Re: Response to Comment Letter Dated October 8, 2020; Application for Modification 20-1 to Mt. Taylor Mine, Permit No. CI002RE, Rio Grande Resources Corporation

This letter is Rio Grande Resources Corporation's (RGR) response to a comment letter by the New Mexico Mining and Minerals Division (MMD) dated October 8, 2020. The letter contained comments on RGR's request for permit modification submitted May 15, 2020. The modification request application was assigned the identifier of "MOD 20-1" by MMD. RGR's permit modification request addressed an update to the reclamation schedule, the expansion of the disposal cell in the south waste rock pile and a proposed modification of the disposition of several structures for the Post Mining Land Use (PMLU).

Responses to MMD's Comment Letter of 10/8/20

RIO GRANDE RESOURCES CORP. MOUNT TAYLOR MINE - San Mateo, NM	PROJECT TITLE: MT. TAYLOR MINE CLOSEOUT/CLOSURE PLAN	
	Prepared By: Alan Kuhn Associates LLC	SHEET TITLE: WASTE ROCK PILE AND DISPOSAL CELL (CONCEPTUAL FULL BUILDOUT)
	SIZE: B SCALE: AS SHOWN FIGURE 1

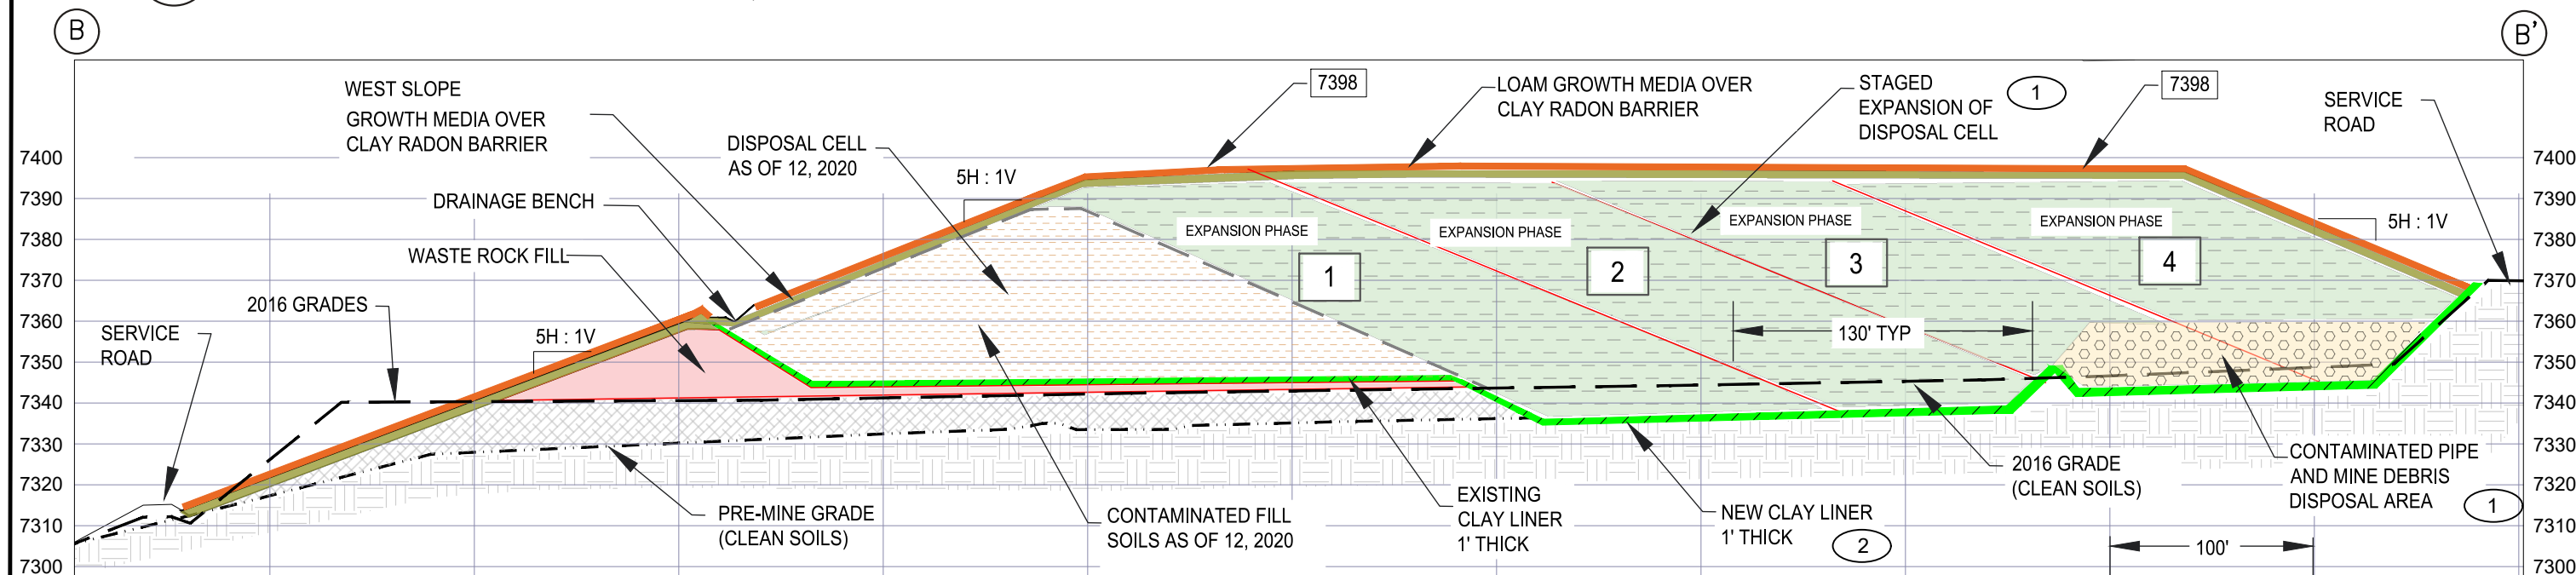
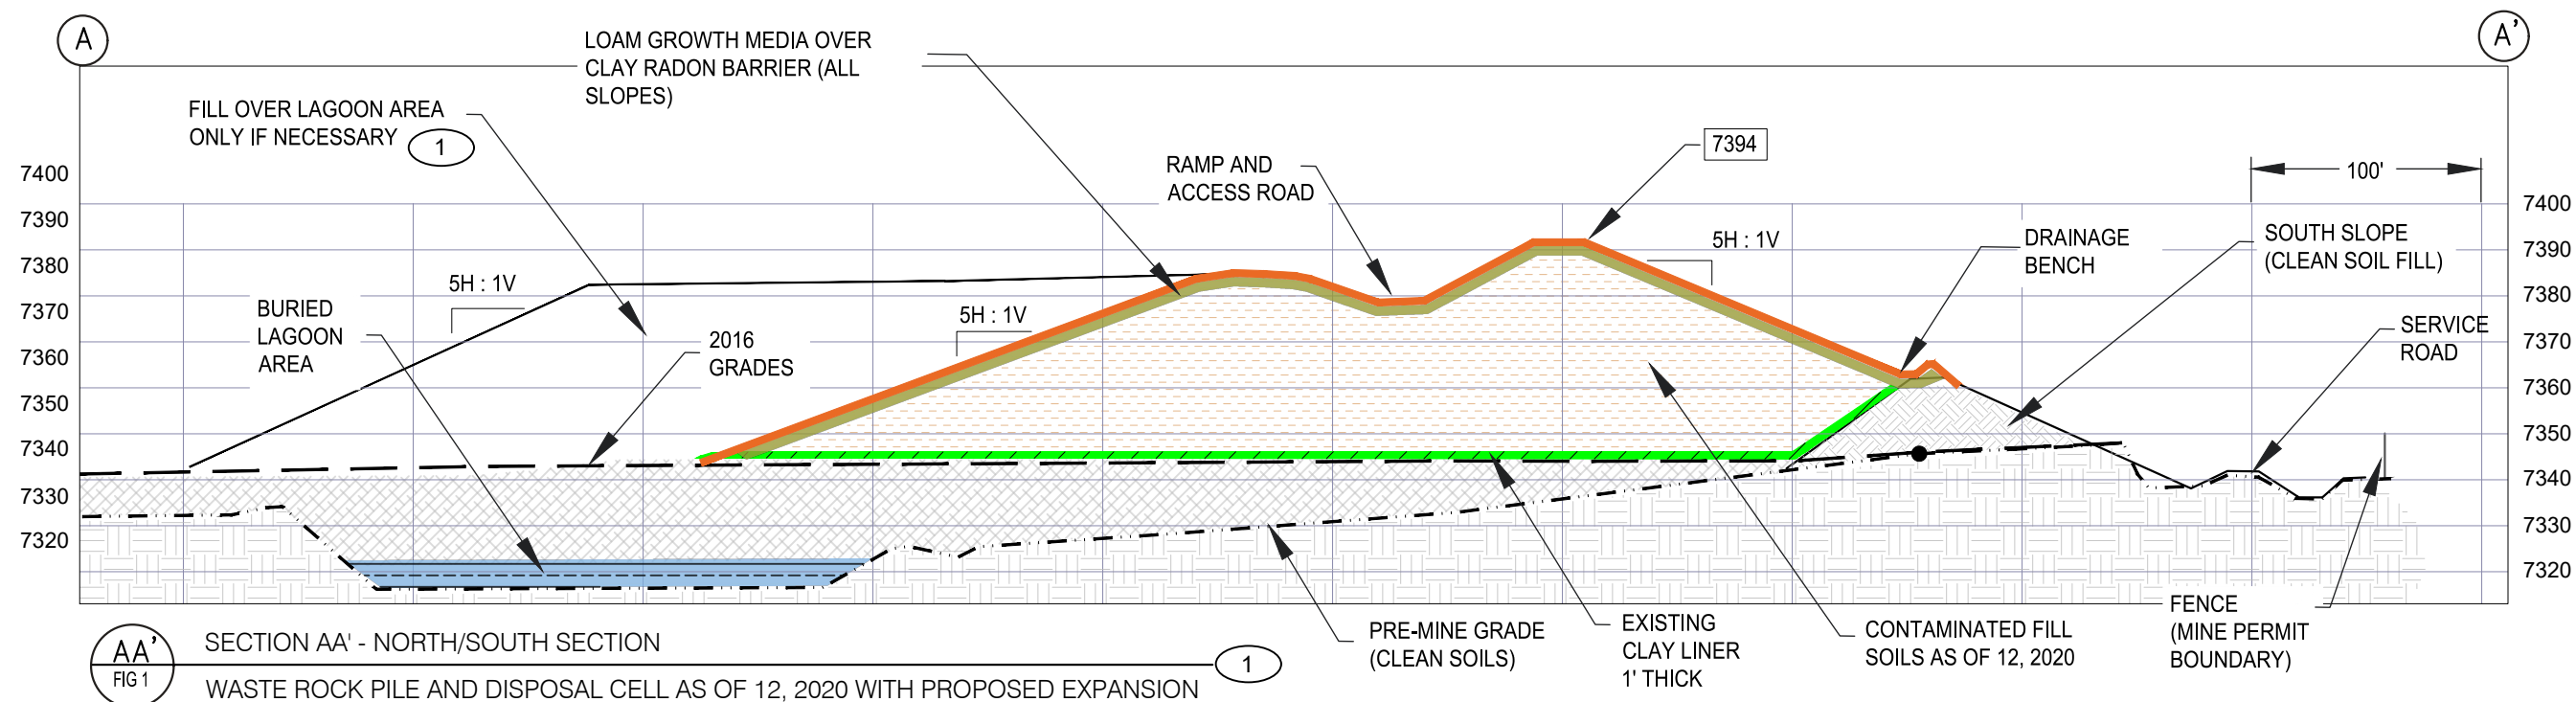
21. *Figure 1, Waste Rock Pile and Disposal Cell (Conceptual Full Buildout) of the Application shows a plan view of the existing Waste Pile and Disposal Cell and the proposed four expansion phases of the Waste Pile and Disposal Cell with two cross-section lines drawn (A- A' and B-B'. Figure 2, Proposed Expansion of Waste Rock Pile and Disposal Cell Sections of the Application shows the cross-sectional drawings A-A' and B-B'. MMD requests additional cross-sectional drawings of each of the four Expansion Cell Phases oriented in a north to south direction.*

Please refer to the attached drawings for the requested cross-sections:

A) "Waste Rock Pile and Disposal Cell (Conceptual Full Buildout), Figure 1",

SHEET TITLE:
PROPOSED EXPANSION OF WASTE ROCK PILE
AND DISPOSAL CELL SECTIONS AA AND BB

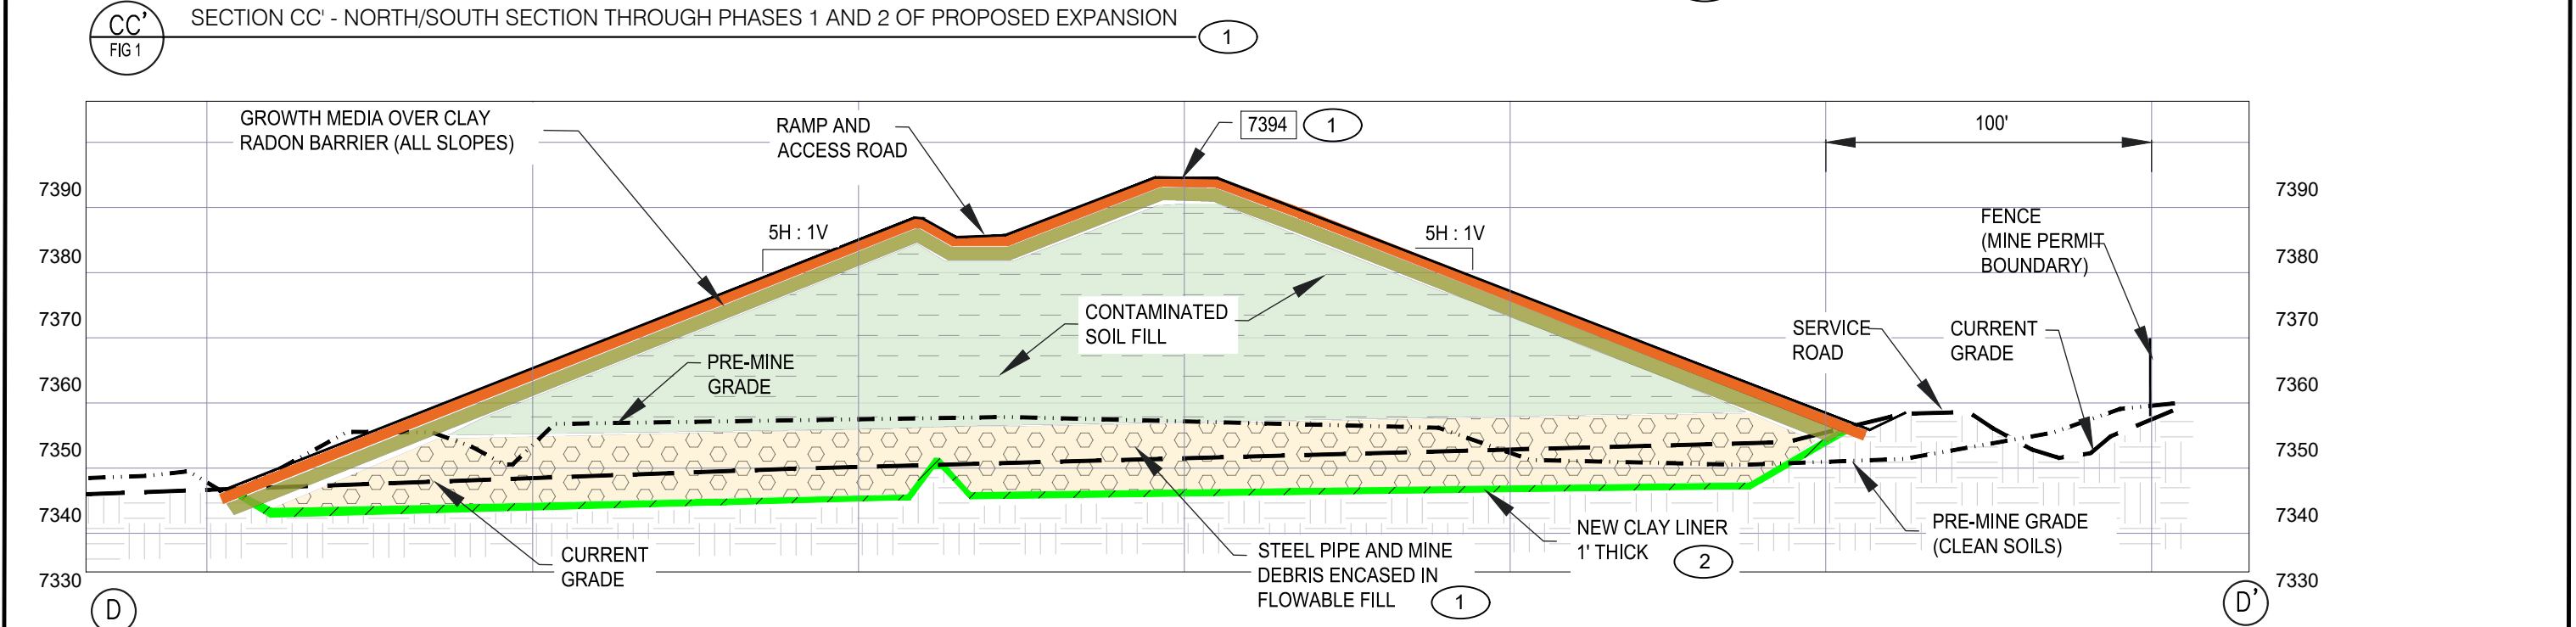
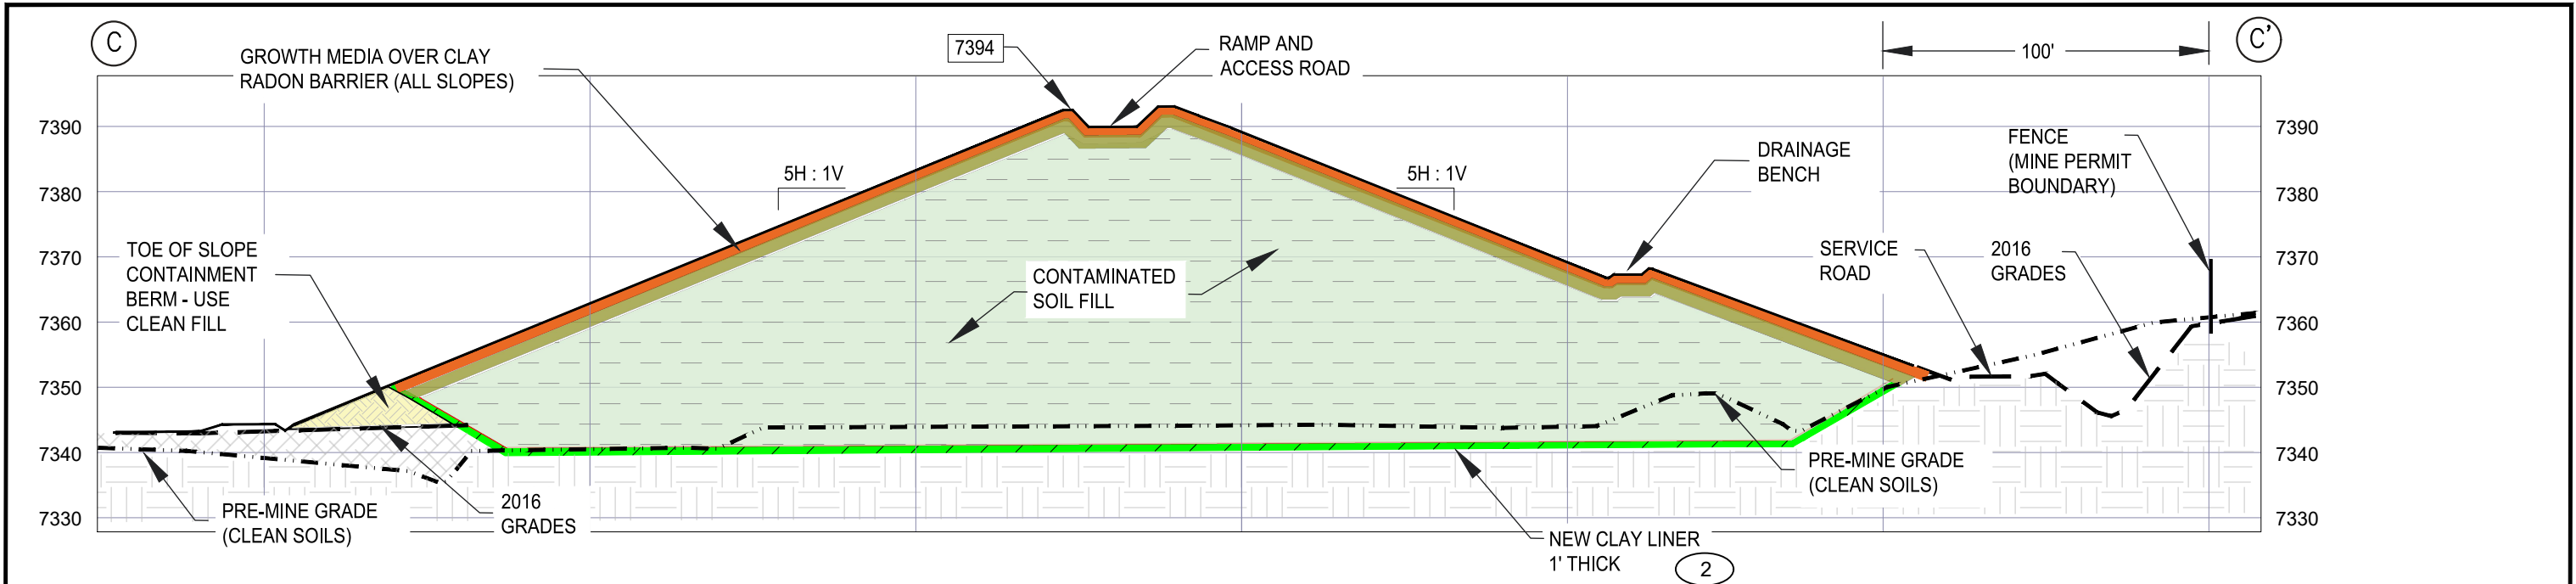
22. *Figure 2, Proposed Expansion of Waste Rock Pile and Disposal Cell Sections of the Application has a caption, Future Contaminated Fill, below and at the A' side of the cross-section drawing. Please explain what this caption refers to in the A-A' cross-section drawing.*

That was a typographical error and should be disregarded. The attached drawing "Proposed Expansion of Waste Rock Pile and Disposal Cell Sections AA and BB, Figure 2" shows the same cross-sectional view, with the typographical error removed.
